Final Safety Evaluation Report Related to the Certification of the Advanced Boiling Water Reactor Design

Appendices

Associate Directorate for Advanced Reactors and License Renewal
Office of Nuclear Reactor Regulation
U.S. Nuclear Regulatory Commission
Washington, DC 20555-0001

Figure G-1 Stability curves for axially loaded compression members, $E = 200 \text{ GPa (29,000 ksi)}$

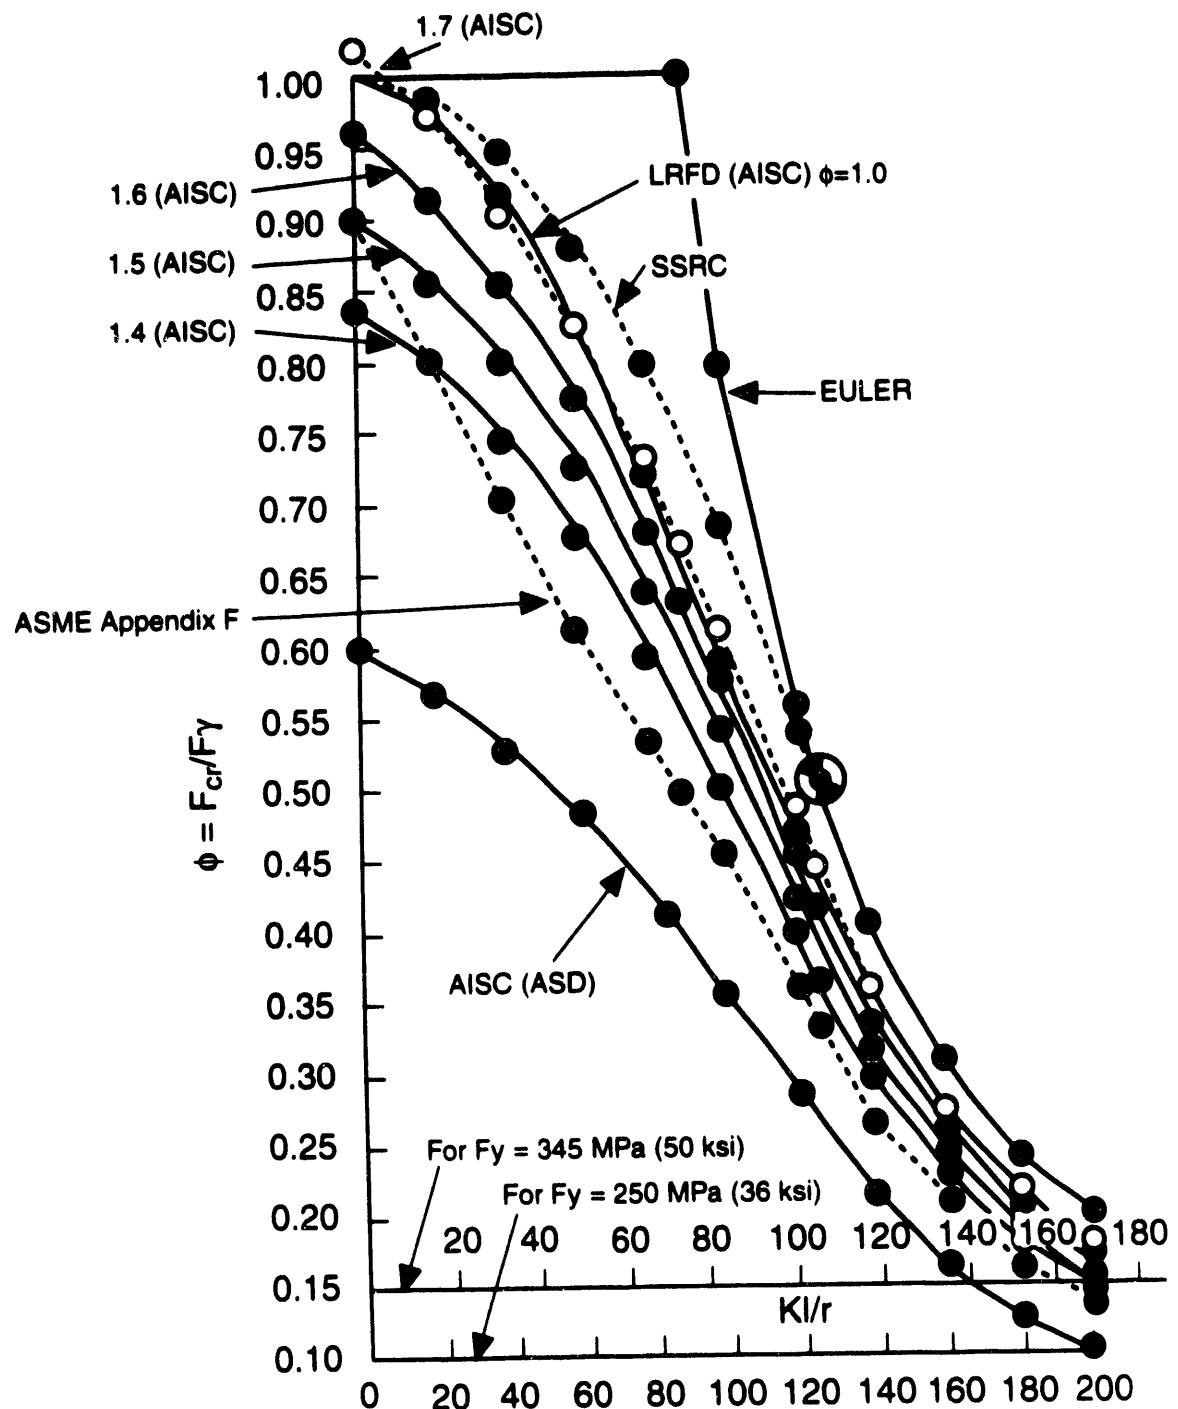
(3) The research done in the last 12 years on the strength and stability of compression members indicates that the base curve (Structure Stability Research Council (SSRC) curve in Figure G-1 of this appendix) used in arriving at the SLCs in SRP Sections 3.8.3 and 3.8.4 and in the standard does not reflect available test data. In developing the American Institute of Steel Construction (AISC) building specification based on the load and resistance factor design (LRFD) concept, the AISC changed the formula for compression members to reflect the test data. The LRFD curve (with $\phi = 1.0$) is also shown in Figure G-1. On the basis of the test data, this curve has a minimum reliability index, β^1 of 2.6 (American Institute of Steel Construction, "Load and Resistance Factor Design Specification for Structural Steel Buildings and Its Commentary," Chicago, Illinois, September 1, 1986). The LRFD specification requires $\phi = 0.85$ in establishing the resistance of compression members.

Figure G-1 shows the curves reflecting the SLCs of 1.0, 1.4, 1.5, 1.6 and 1.7 as applied to the stresses specified for the allowable stress design (ASD) of AISC. On the basis of the comparison with the LRFD curve ($\phi = 1.0$), the following SLCs are recommended:
